# Duquesne Light

2NRC-4-150

SUBJECT: Beaver Valley Power Station - Unit No. 2  
Docket No. 50-412  
PSB Electrical Outstanding Issues

This letter forwards responses to the issues listed below which were provided by PSB in a draft SER on June 8, 1984. FSAR Changes described in these responses are intended to be incorporated upon acceptance by PSB. The following items are attached:

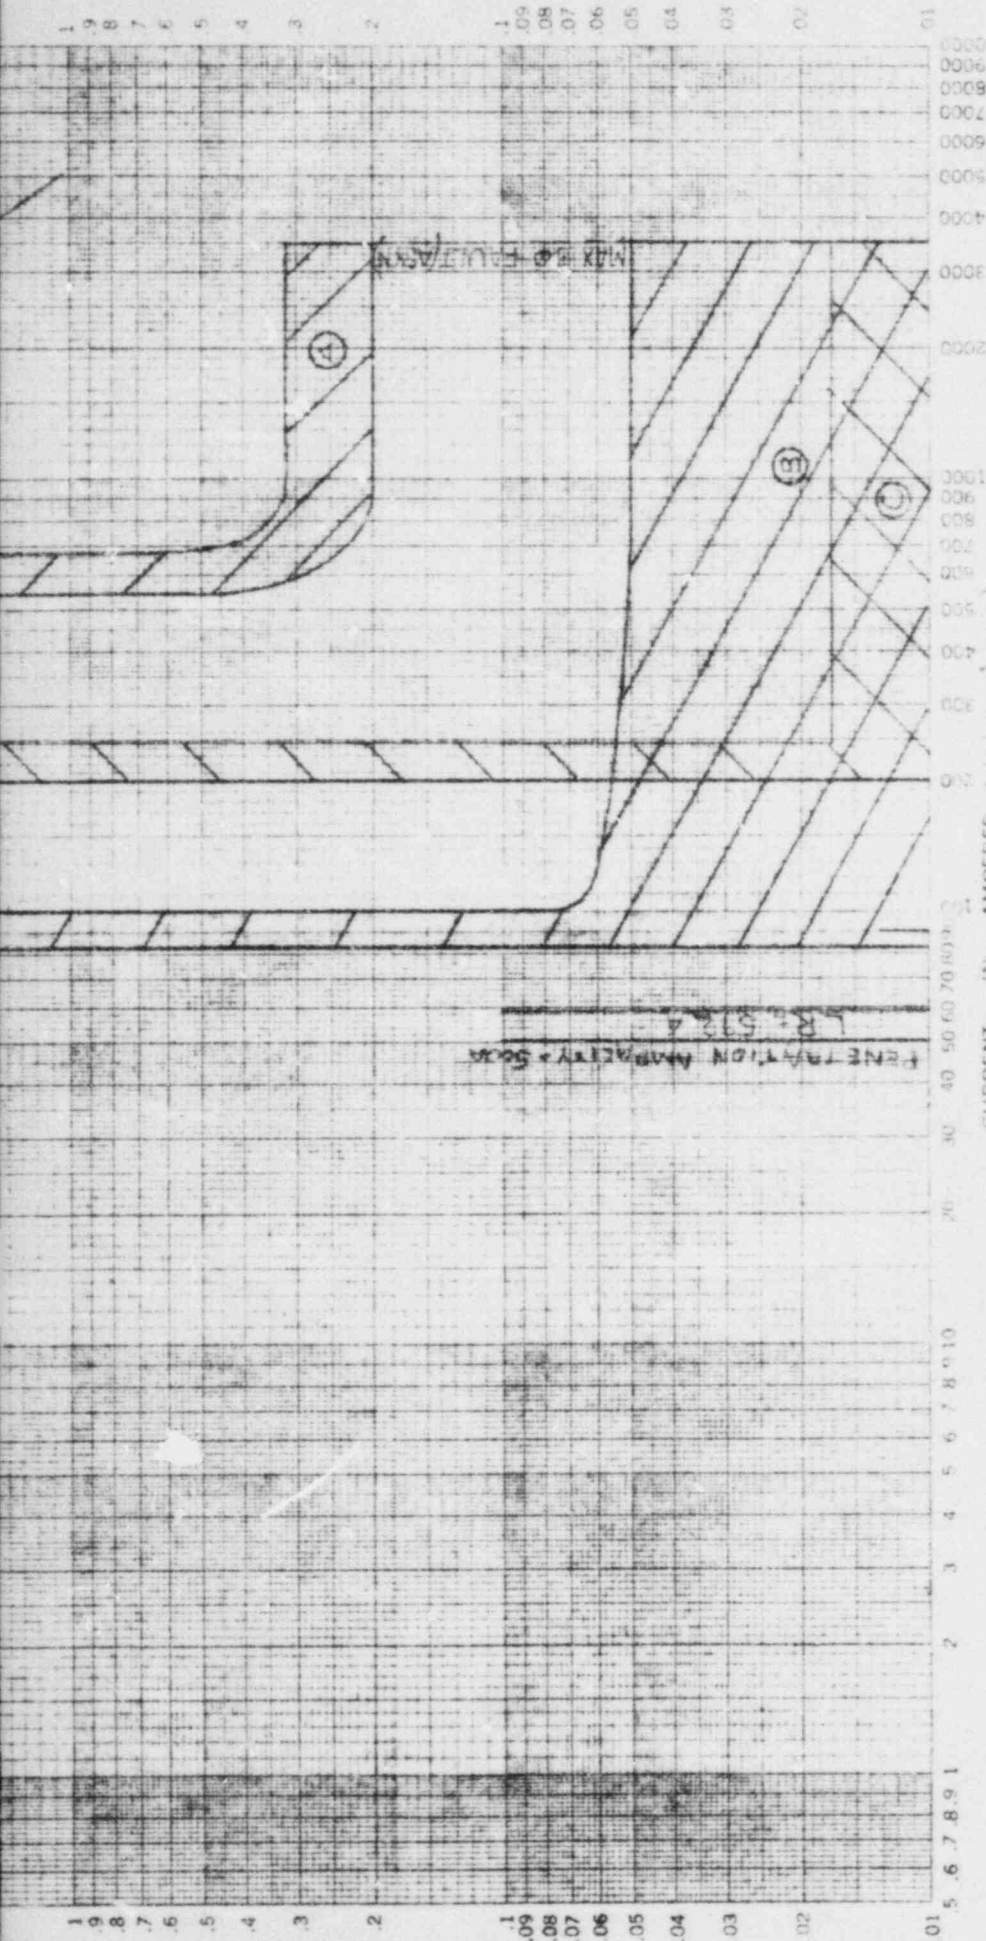
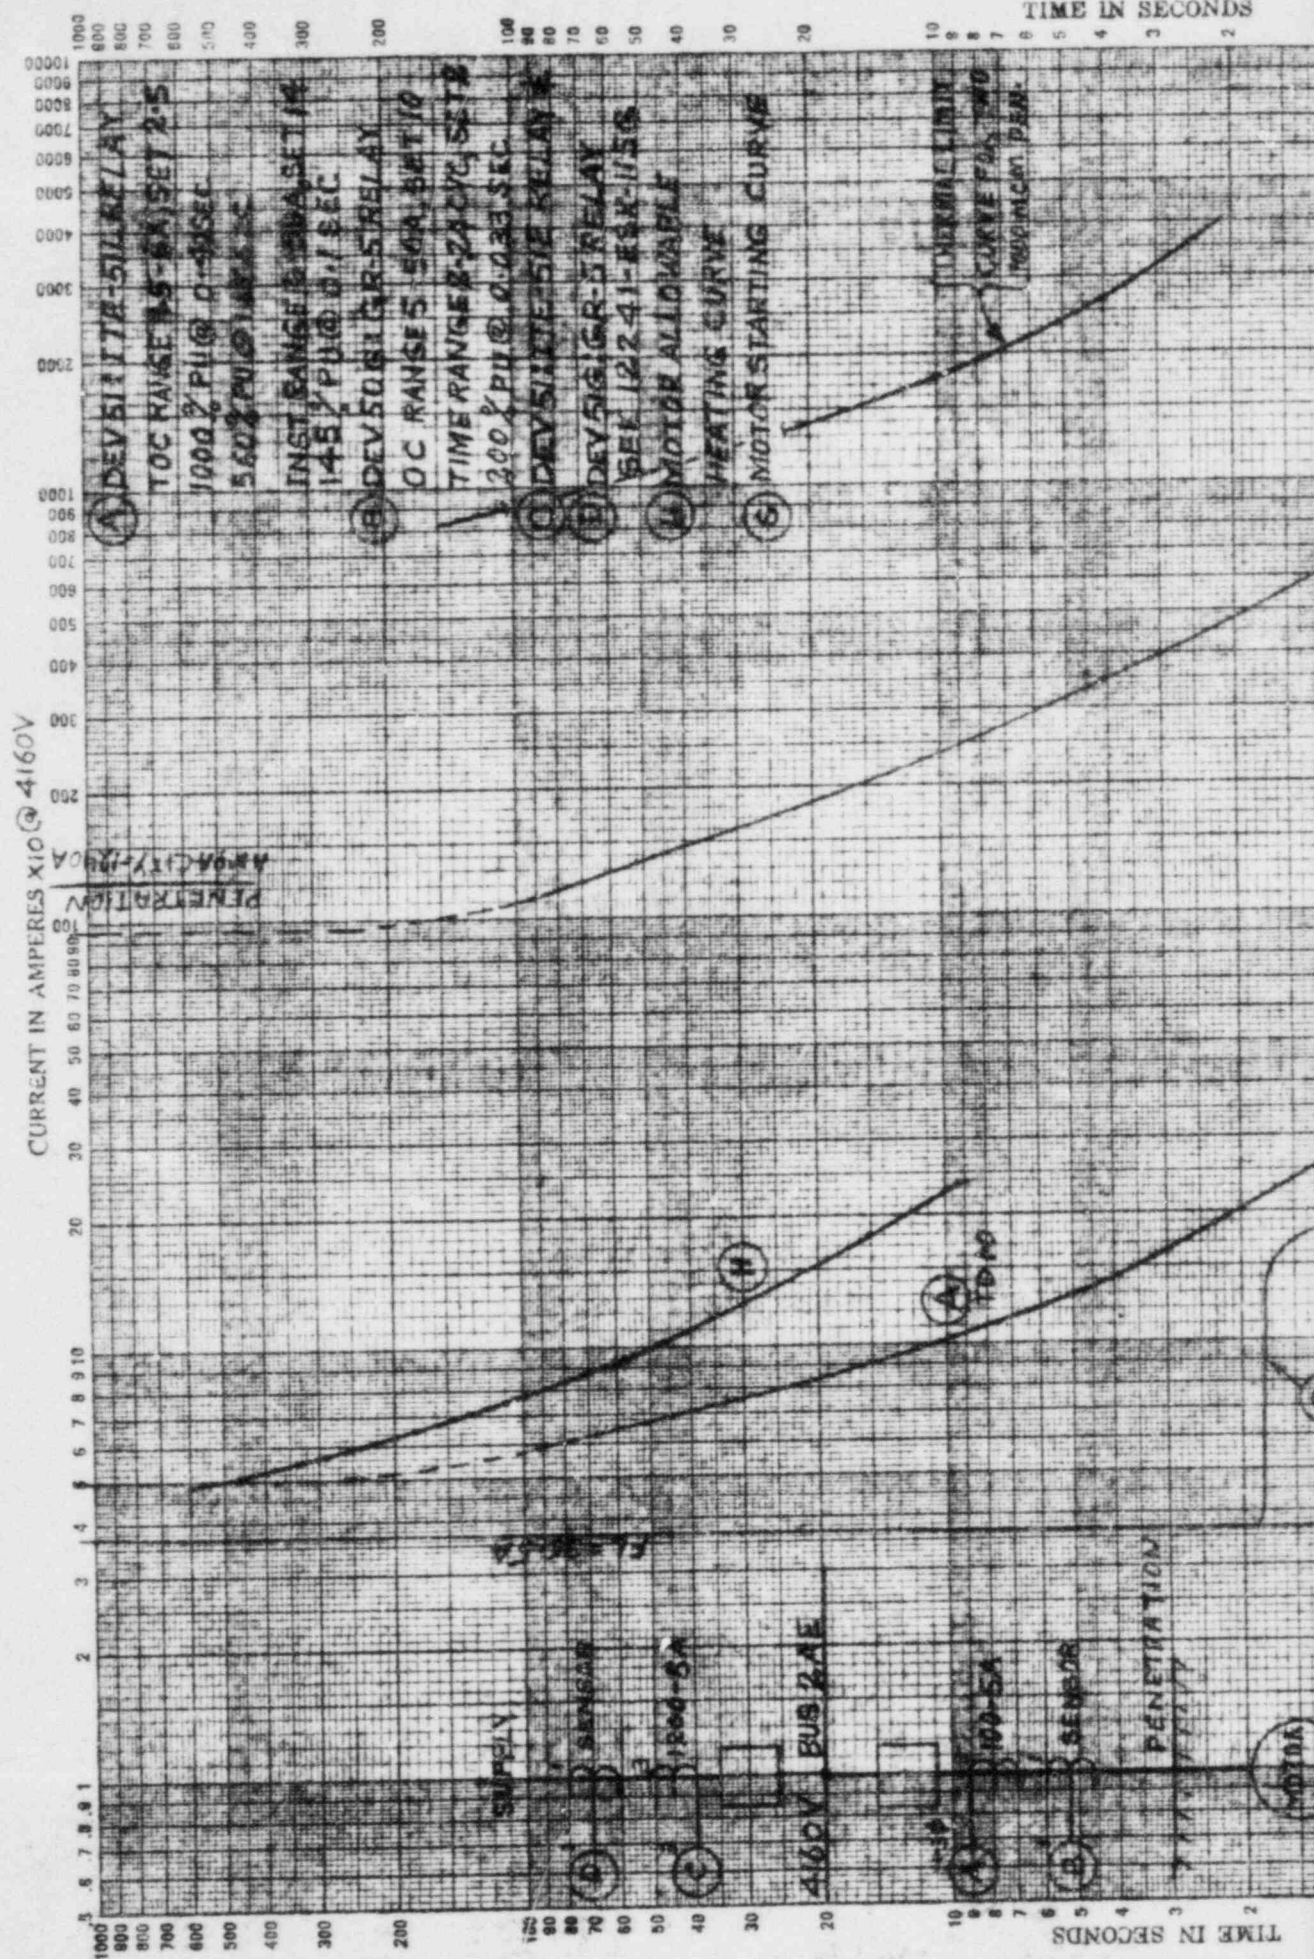
Section 8.3.1.2.1 of the FSAR indicates that primary and backup containment electrical penetration protection is provided only where the available fault-current exceeds the current-carrying capabilities of penetration conductors. This design for containment electrical penetration does not meet the guidelines of position 1 of Regulatory Guide 1.63. Position 1 requires primary and backup protection where maximum available fault-current exceeds the current-carrying capability of the penetration versus capability of the conductors.

- a. fault-current versus time curve for each representative type cable conductor which penetrates primary containment
- b. test report which verify the capability of penetration to withstand the total range of time versus fault current for worst case environmental conditions

- a. fault-current versus time curves for each representative type cable conductor which penetrates primary containment
- b. test report excerpts which verify the capability of penetrations to withstand the total range of time versus fault current for worst case environmental conditions
